CCO No.	Suppl. No.	Contract No.	Contract Name	Federal Number(s)
3		8597 Project No. 36204002	Patterson Drive Emergency Culvert Repair Project	NA

EL DORADO COUNTY
DEPARTMENT OF TRANSPORTATION
Contract Change Order

PATTERSON DRIVE EMERGENCY
 CULVERT REPAIR PROJECT

SHEET
P&D
 3 OF 4
 CONTRACT No.
8597

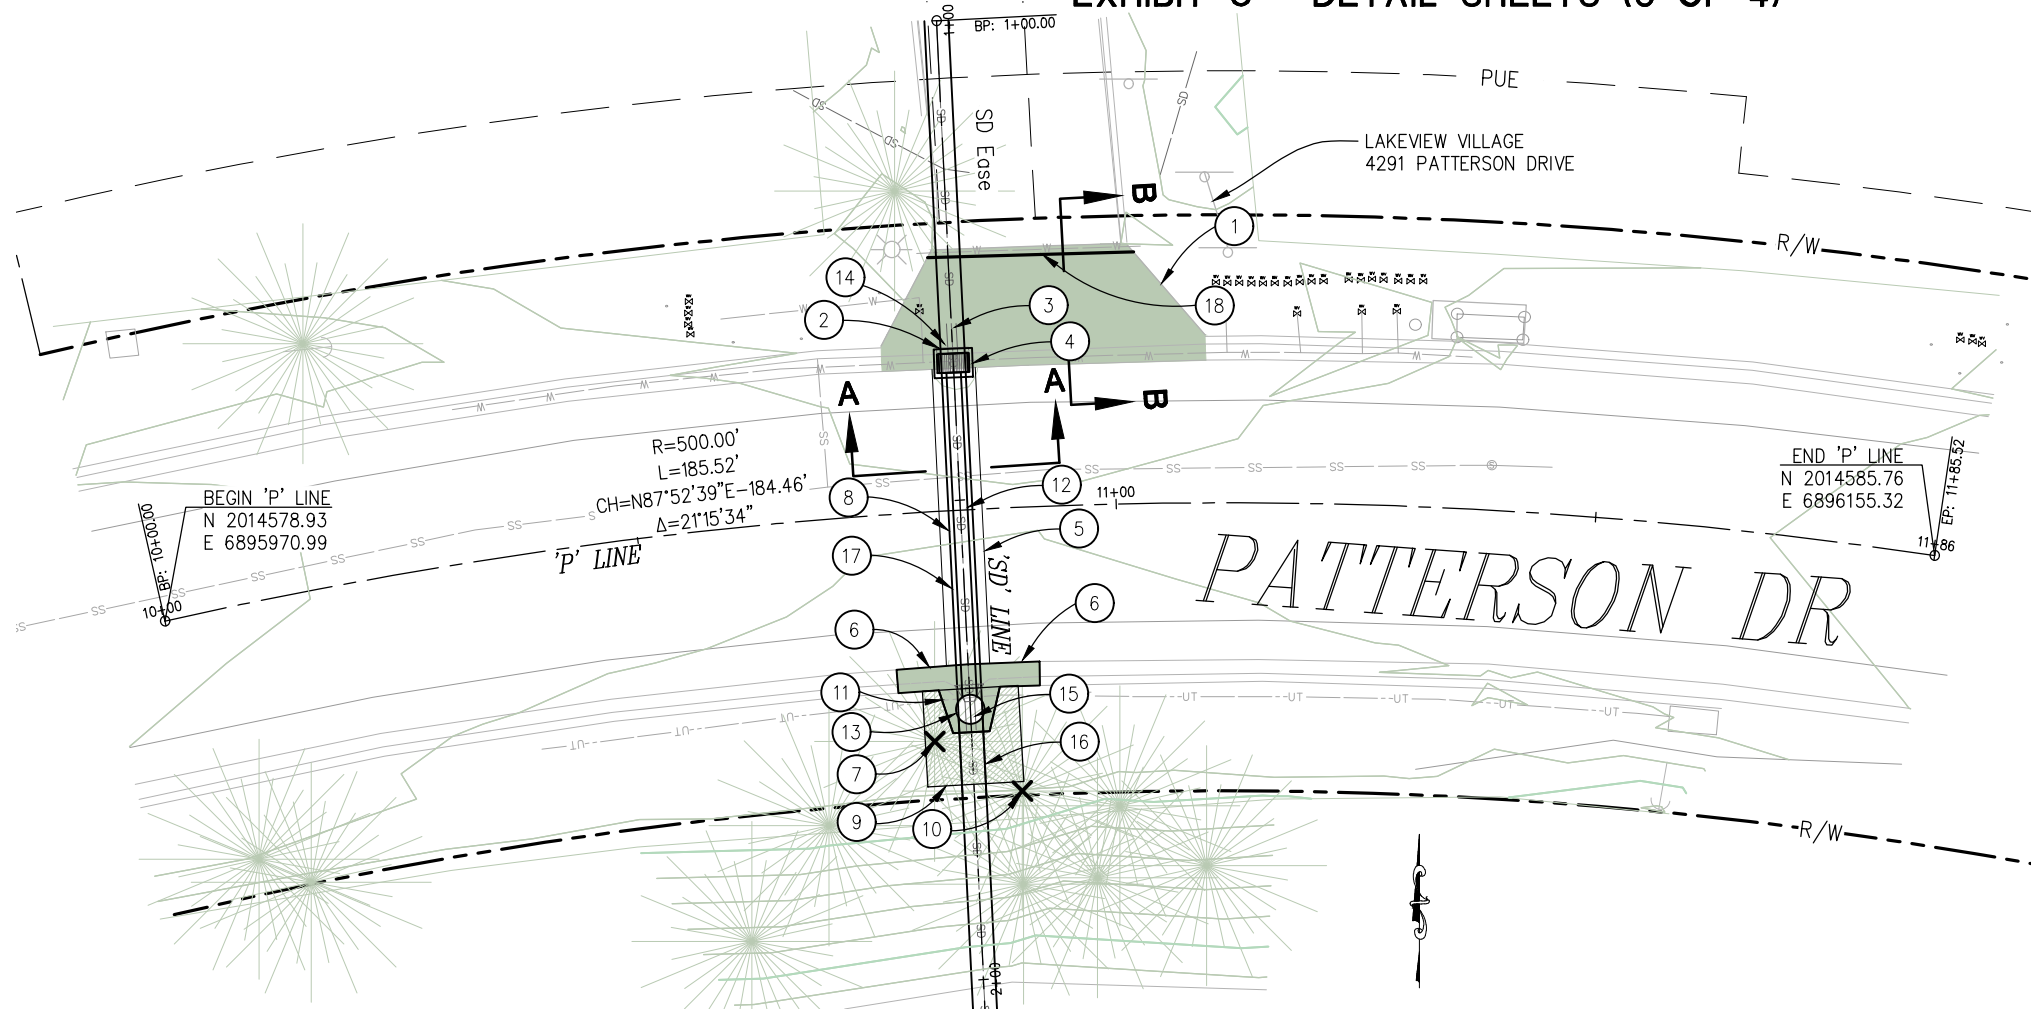
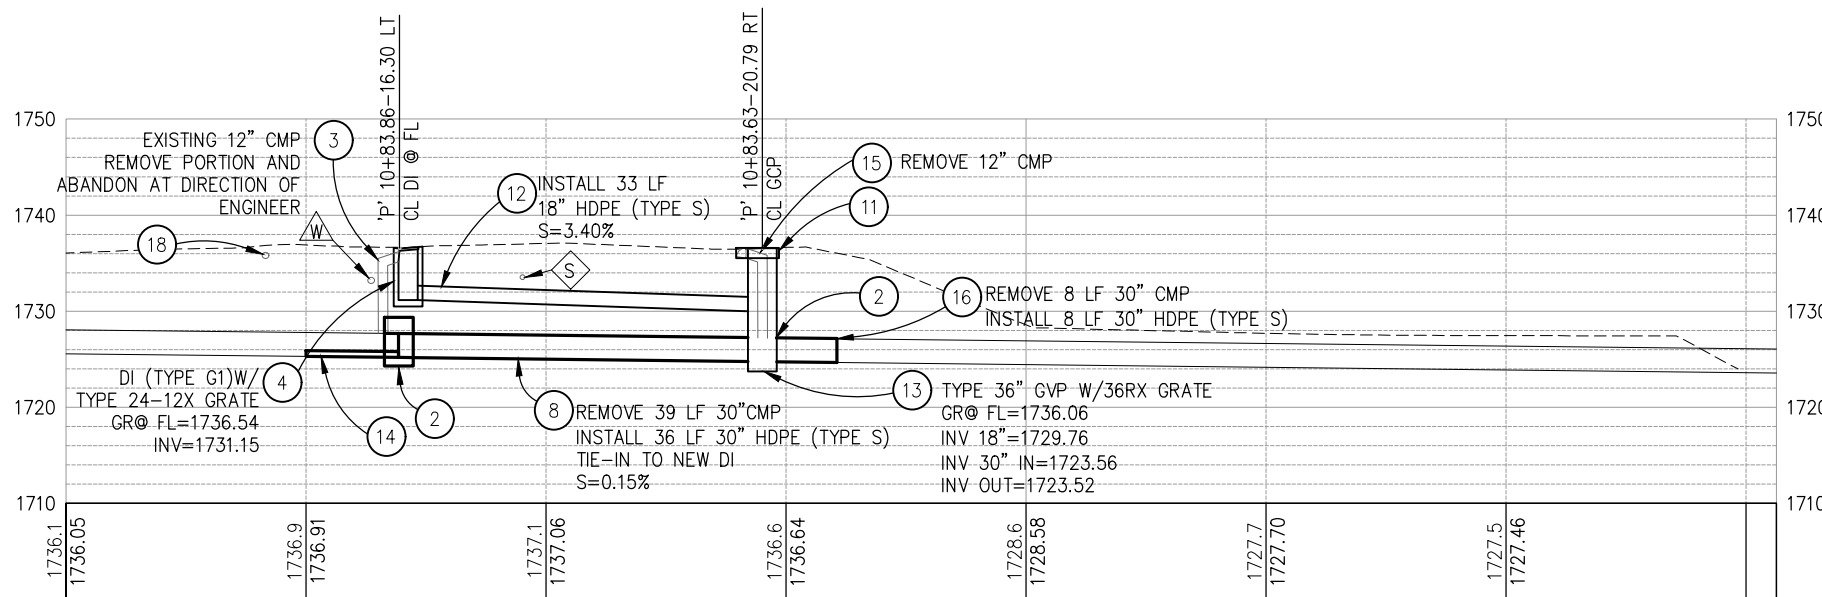
In accordance with Standard Specification 4-1.05, Changes and Extra Work, and as shown on sheets 4 and 5 of this Contract Change Order #3, revise the scope of the drainage system installation to account for over excavation and additional slurry-cement backfill due to saturated subgrade conditions caused by the failed existing 30" CMP and rainwater intrusion. Perform additional Roadway Excavation and Culvert Slurry-Cement Backfill at the following agreed quantities and Contract Bid Item Prices:

- CC03 - REMOVE AND REPLACE CURB AND/OR GUTTER (MATCH EXISTING) 20 LF BOTH SIDES OF DI. SLOPE TO DRAIN TO DI.
- REMOVE 18" STUMP.
- REMOVE 39 LF 30" CMP. REPLACE W/ 36 LF 30" HDPE (TYPE S) AND CONNECT TO GCP.

- CC03 - REMOVE SATURATED MATERIAL BELOW PIPE - CAST NEW PIPE FLOWLINE WITH 6-SACK CONCRETE REINFORCED WITH 6" WELDED WIRE MESH AS DIRECTED BY ENGINEER.

- CC03 - REPLACE UNMARKED EXISTING 3/4" IRRIGATION LINES WITH 4" PVC CONDUIT CONTAINING TWO 3/4" IRRIGATION LINES TIED INTO EXISTING LINES ON EACH SIDE OF DRIVEWAY.

SHEET
CD
4 OF 4
CONTRACT No.
8597

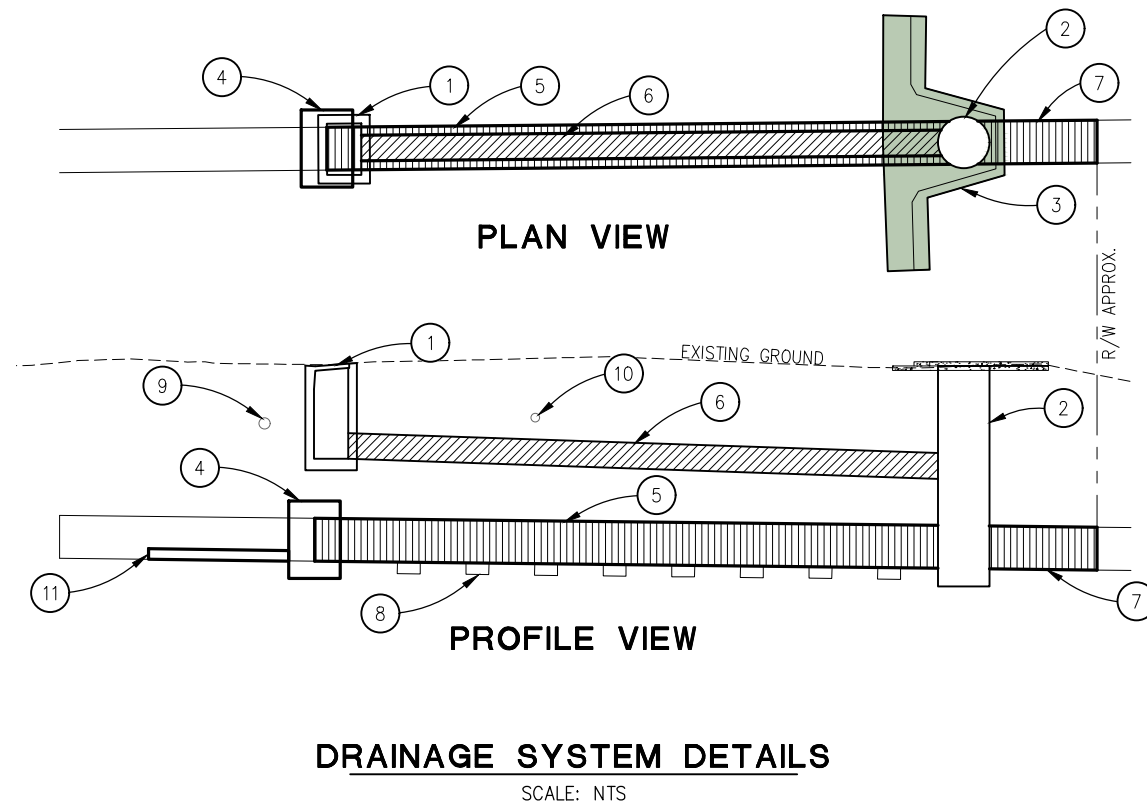
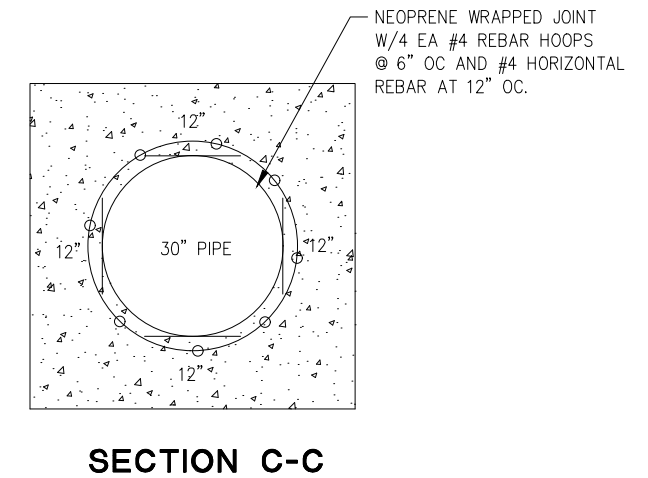
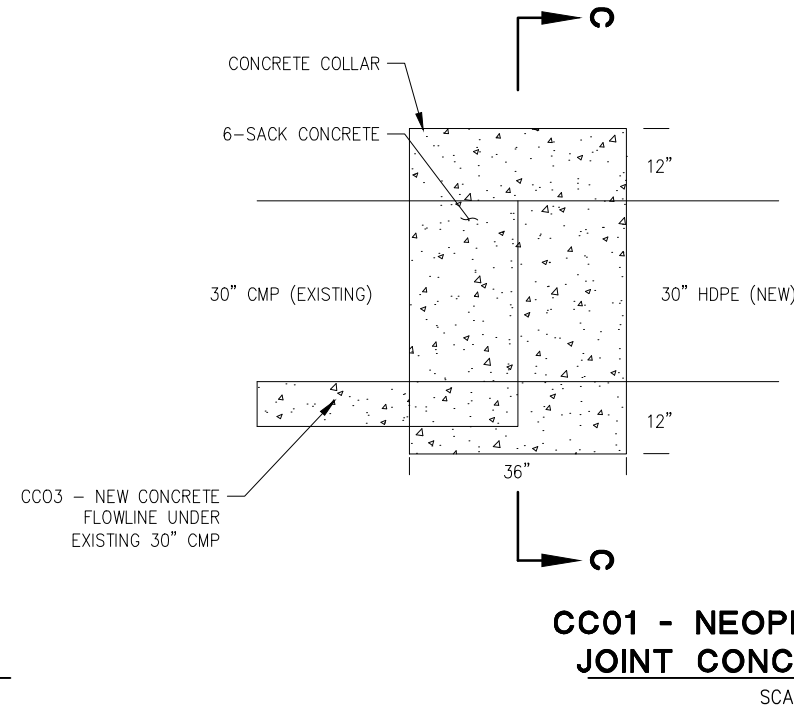
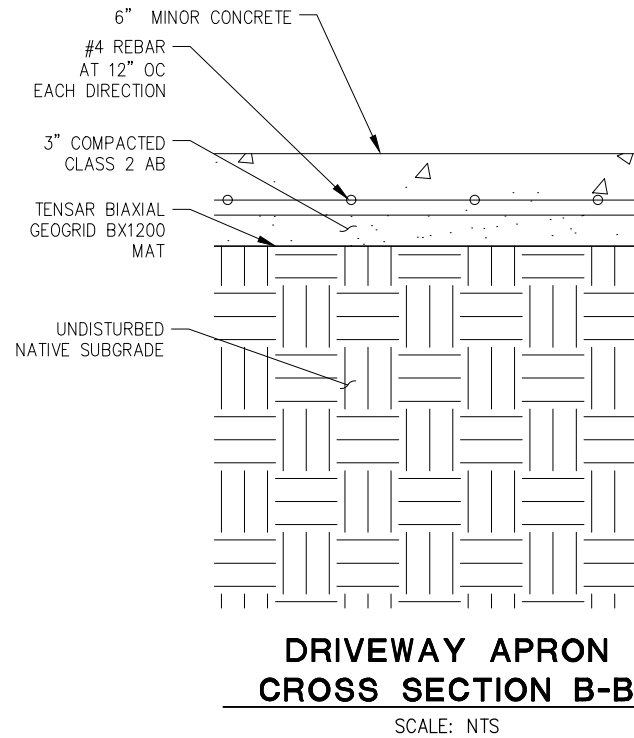
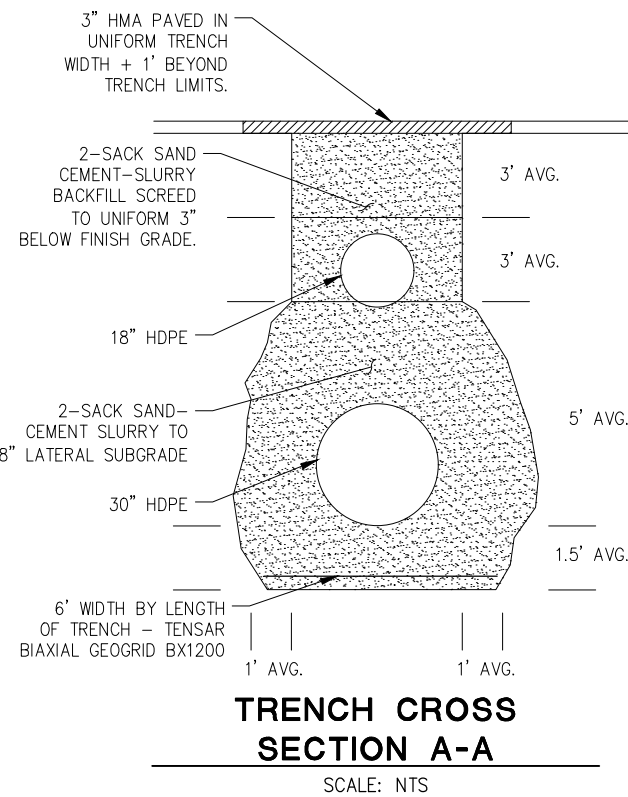
- 8 - CC03 - 2'X8"X16" BRICK EVERY 4' OC (TYPICAL). LOW SLUMP 2 SACK SAND SLURRY BACKFILL FROM BOTTOM OF 1.5' OVER EXCAVATION UNDER 30" HDPE TO 18" HDPE SUBGRADE - THEN 2-SACK SAND-CEMENT SLURRY FROM BOTTOM OF 18" HDPE TO 3" BELOW HMA FINISH GRADE.

- 9 - EXISTING EID WATER LINE.
- 10 - EXISTING SEWER LINE. MAINTAIN 1' SEPARATION FROM BOTTOM OF SEWER LINE TO TOP OF 18" HDPE.
- 11 - CC03 - REMOVE SATURATED MATERIAL BELOW PIPE - CAST NEW PIPE FLOWLINE WITH 6-SACK CONCRETE REINFORCED WITH 6" WELDED WIRE MESH AS DIRECTED BY ENGINEER.
